PLANNING CLEARANCE
 (Single Family Residential and Accessory Structures)
 Grand Junction Community Development Department

BLDG ADDRESS 2469 Cimarron Dr TAX SCHEDULE NO. 2701-334-17-003
 SUBDIVISION North Valley SQ. FT. OF PROPOSED BLDG(S)/ADDITION 2100
 FILING 1 BLK 1 LOT 3 SQ. FT. OF EXISTING BLDG(S) NA
 (1) OWNER G Road LLC NO. OF DWELLING UNITS BEFORE: 0 AFTER: 1 THIS CONSTRUCTION
 (1) ADDRESS 22 Pyramid Rd NO. OF BLDGS ON PARCEL BEFORE: 0 AFTER: 1 THIS CONSTRUCTION
 (1) TELEPHONE 970-920-1136 Aspen 8161 USE OF EXISTING BLDGS NA
 (2) APPLICANT Michael Bennett DESCRIPTION OF WORK AND INTENDED USE: New
 (2) ADDRESS 22 Pyramid Rd, Aspen SF residence
 (2) TELEPHONE 970-920-1136

Plot Plan: 2469 Cimarron Dr.

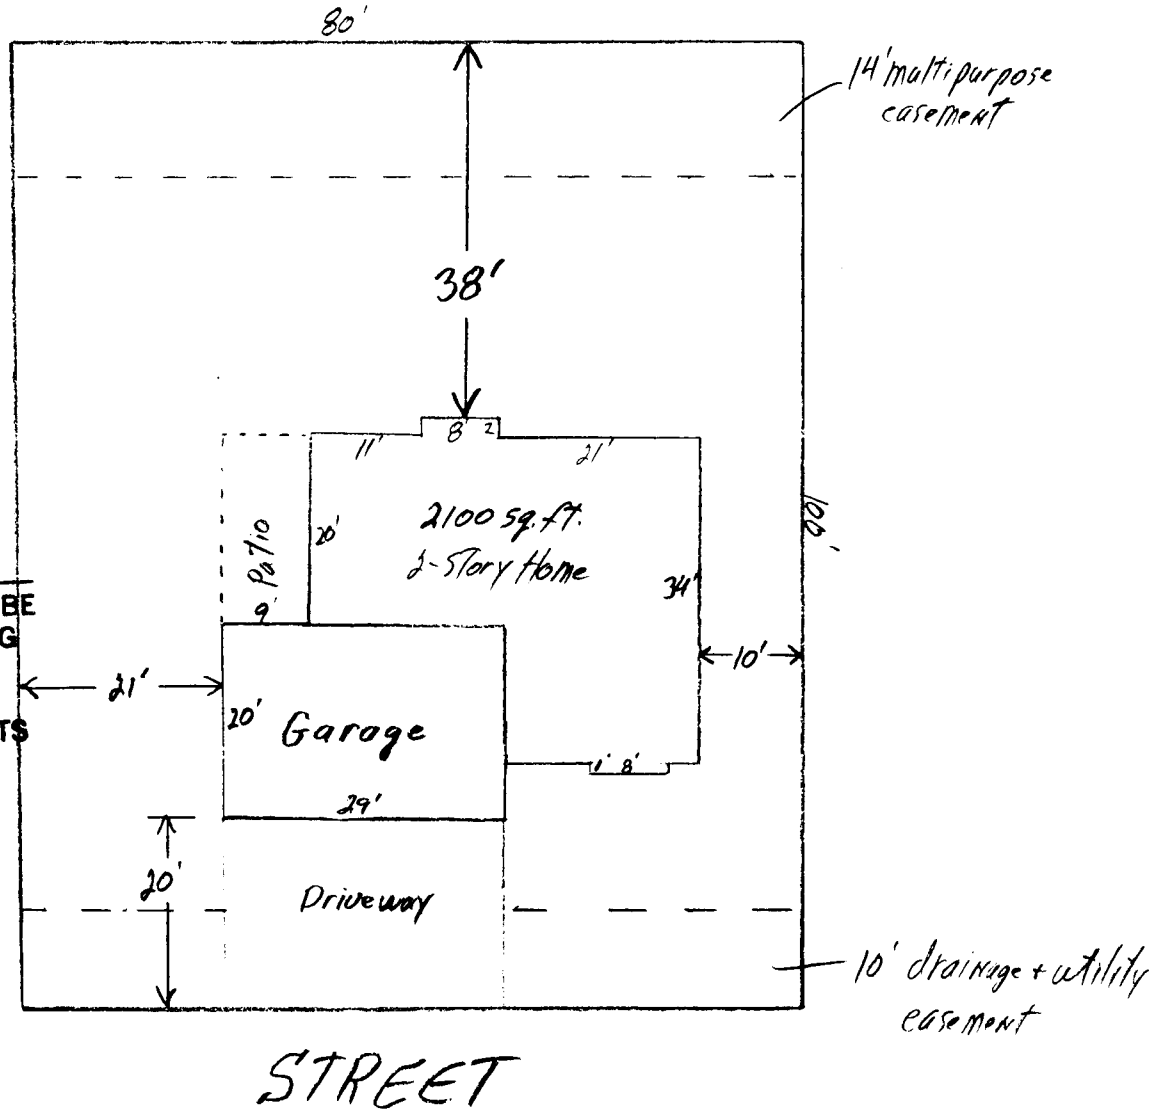
ACCEPTED MR 2-5-96
 ANY CHANGE OF SETBACKS MUST BE APPROVED BY THE CITY PLANNING DEPT. IT IS THE APPLICANT'S RESPONSIBILITY TO PROPERLY LOCATE AND IDENTIFY EASEMENTS AND PROPERTY LINES.

DRIVEWAY LOCATION
 OK
